Re: District 1 Lots 2&4 - SD13-0010– August 2014 Resubmittal

Review Comments DISTRICT 1 LOTS 2 & 4

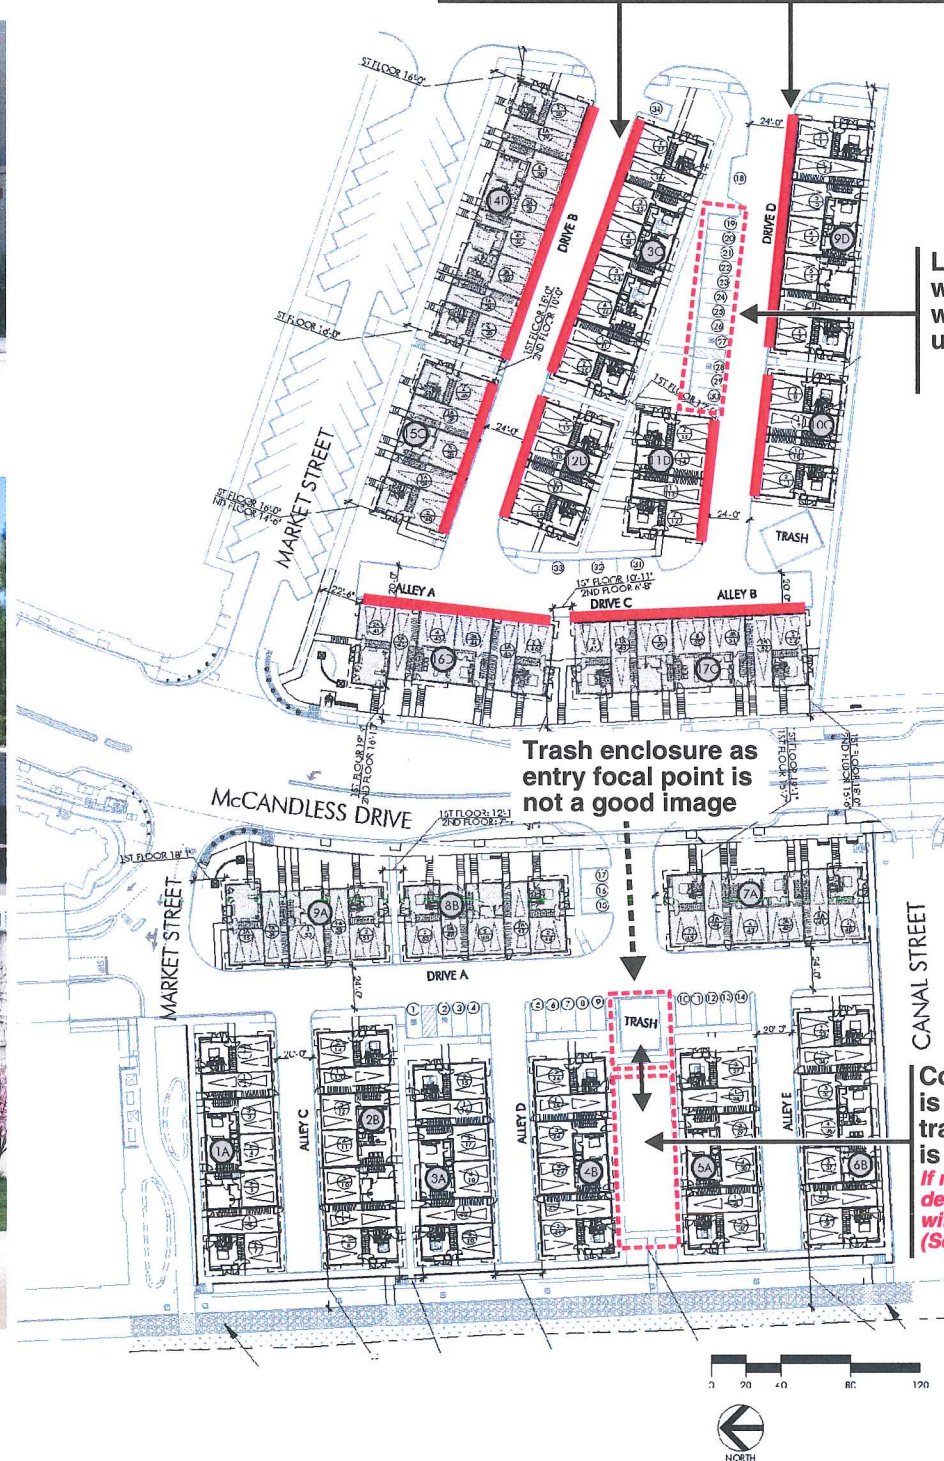
Long rows of garages on auto drives are likely to be visually unpleasant without landscaping to soften appearance.
Guests are also subjected to this streetscape

Long row of guest parking would be better for streetscape with landscaped islands to break up the line of parked cars

Trash enclosure as entry focal point is not a good image

Common open space is much improved but trash enclosure location is most unfortunate.
If no other location is possible, design and screen enclosure with high quality landscaping (See some examples to the left)

Front elevations have good variety and balance of vertical and horizontal elements
Rear elevations have more variety than Centre Pointe Lots B & C but still needs landscaping to break up the long rows of garages
